NOTE: Non-professional extra-jurisdictional advice offered only for discussion purposes; WITHOUT RESPONSIBILITY

# Assumptions

For 4-Permits

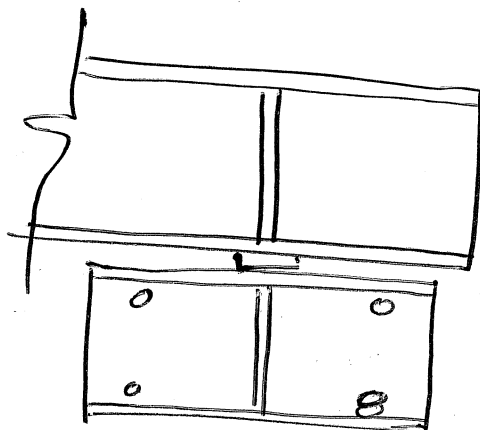
- 1) "Deck" resting on Channel is composite to, or at minimum fully capable of restraining (Diaphragm)
- 2) Channel cannot simply be embedded into wall [ie: Modify as below or can be embedded]

← Block Permits notation.

IF Channel may be embedded:

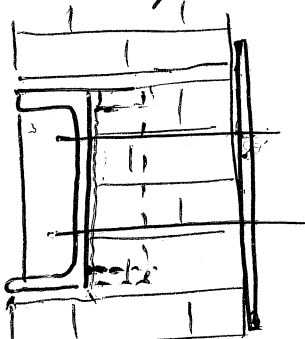
\* If bearing is exceeded with a Channel, there is no reason not to embed an I-section.

Also: The contractor should needle/key the wall Temp.
